**Economic Commission for Europe****Inland Transport Committee****World Forum for Harmonization of Vehicle Regulations****Working Party on Passive Safety****Fifty-ninth session**

Geneva, 9-13 May 2016

**Regulation No. 16 (Safety-belts)****Proposal for Supplement 8 to the 06 series of amendments to Regulation No. 16 (Safety-belts)****Submitted by the expert from the European Association of Automotive Suppliers \***

Figure 2

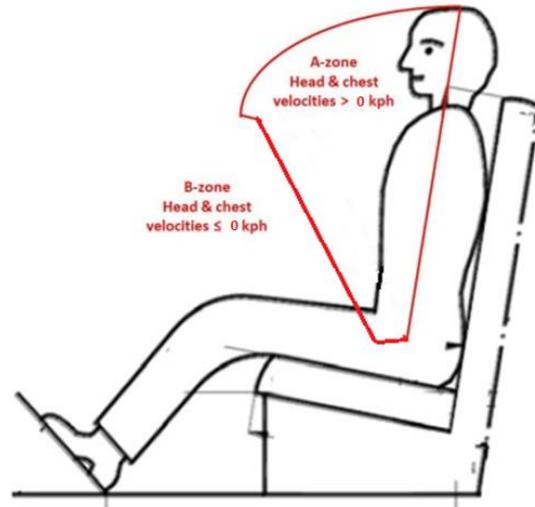
"12.1. In case a restraint system has been granted/refused/extended/withdrawn<sup>2</sup>, those can be used for particular types of vehicles compatible with the following dimensional conditions: no interior part in a quoted A-zone as shown below (Figure 2):
